**Flood Control Project Maintenance  
Levee Inspections**  
**LMA District Cover Sheet**  
**Spring 2018 Levee Inspection Results**

**City of Sacramento**

**Levee Inspection Report By Mile - Spring 2018**

Photo 1 of 1 : UCIP\_SP\_2018\_41418\_72741.jpg

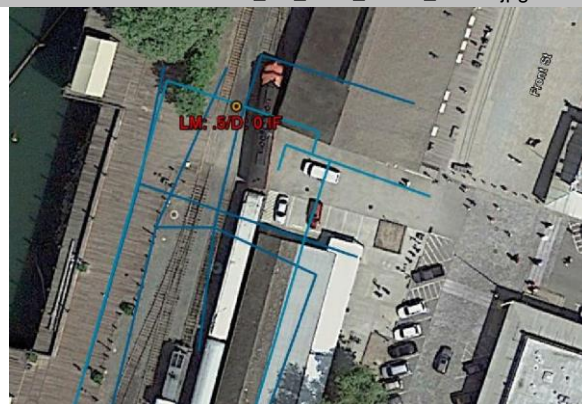
LM Start	0.50	Rating **	M	Issue No.	111
LM End	0.50	Issue Type +	En	Location *	
Category	Supplemental			GPS Latitude/Longitude	
				Start	End
Item	DWR UCIP Field Study			38.583693 °	38.583693 °
				-121.505909 °	-121.505909 °
DWR ID					
Comment Code					
Inspector Comment					
FS_ID:41418					
DS_ID:24894					
EP_NO: N/A					
Repair Type: Non-Urgent					
Crossing Status: Indicator Found					
UCIP Comments: Need to confirm status of crossing and alignment through levee. Unable to find permit during review.					
FIELD_STRUCT_DESC: 8-inch drainage pipe of unknown material through levee at unknown depth below the levee crown and along waterside (WS) for about 800 feet. Crosses levee again at 38.581544, -121.506688.					
FS Date: 3/6/2013

Aproximate alignment provided by City of Sacramento -- unable to confirm if crossing is active.

Photo 1 of 1 : UCIP\_SP\_2018\_41419\_72742.jpg

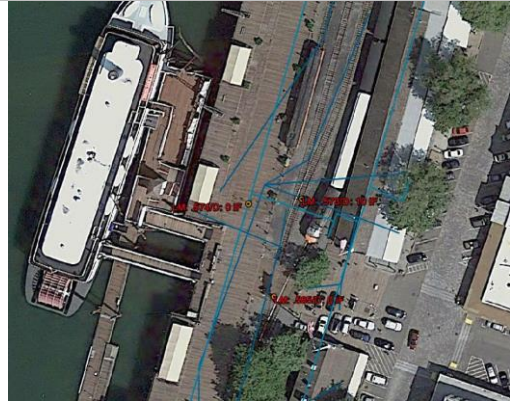
Comment Code					
Inspector Comment					
FS_ID:41419 DS_ID:24895 EP_NO: N/A Repair Type: Non-Urgent Crossing Status: Indicator Found UCIP Comments: 06/06/2017 Received documentation from the City of Sacramento indicating that this crossing was internally inspected on 10/28/2013, PACP Sewer Report was provided. PACP report is missing rating evaluation. No additional information was received from the City of Sacramento. Need to request evaluation of pipe (integrity of pipe section through the levee) and find out when the City is planning the next internal inspection for this pipe. (DWR UCIP – O. Magana) 03/06/2013 Need to confirm if crossing is still present. No signs visible during site visit. No photos available. FIELD_STRUCT_DESC: 10-inch vitrified clay drainage pipe through levee at an unknown depth. Record was obtained from the City of Sacramento's kml file with approximate utility alignment. FS Date: 3/6/2013

Approximate alignment provided by the City of Sacramento--unable to confirm crossing in field.

Photo 1 of 2 : SP\_2018\_NA0005\_251\_1\_20180319\_00001.jpg

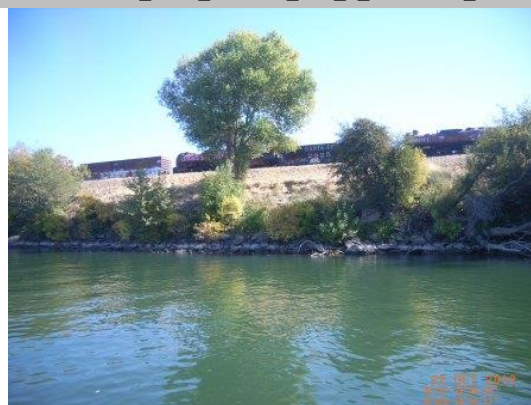
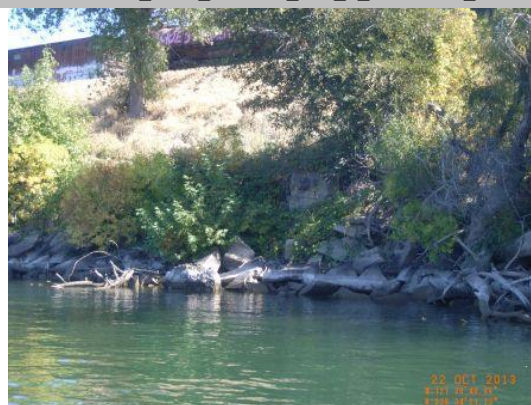
LM Start	1.31	Rating **	M	Issue No.	1
LM End	1.39	Issue Type +	Ma	Location *	WS
Category	Supplemental			GPS Latitude/Longitude	
				Start	End
Item	2015 USACE Erosion Survey, DRAFT			38.573169 °	38.572277 °
				-121.511998 °	-121.513063 °
DWR ID	DWR_NA0005_01_s _ 2016_1				
Comment Code					
Inspector Comment					
2008 - Oversized levee, should be repaired under maintenance. 2009 - Shallow slumps at the mid bank. 2010 - Some minor erosion at the toe, likely from wave wash. Some new shallow slumps. 2011 - One new tree has fallen. 2013 - Erosion continues on the slope surface, site extended upstream. 2015: No observed changes. [2015 Site ID: SAC_58-5_L]

Photo 1 of 3 : UCIP\_SP\_2018\_49778\_34024.jpg

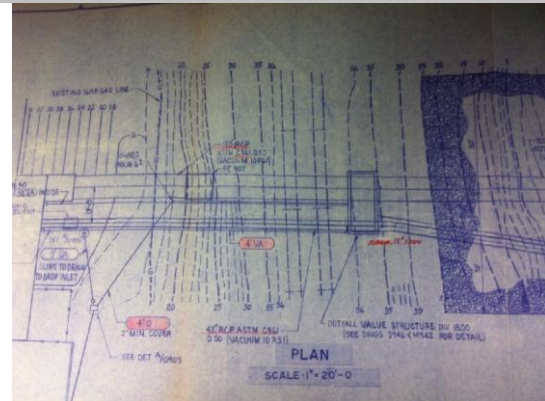
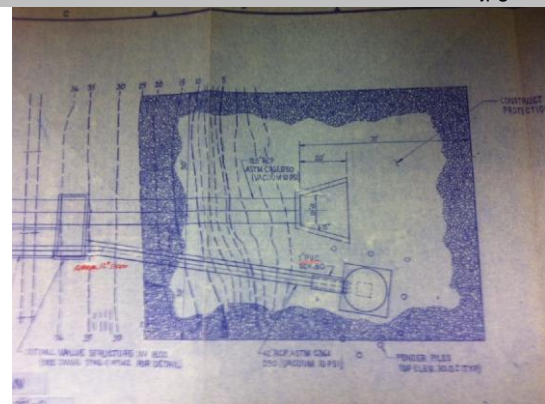
DWG showing 42-inch and 120-inch pipes through levee and connection to outfall valve structure.

Rip rap protection around outfall structure for 42-inch and 120-inch pipes.
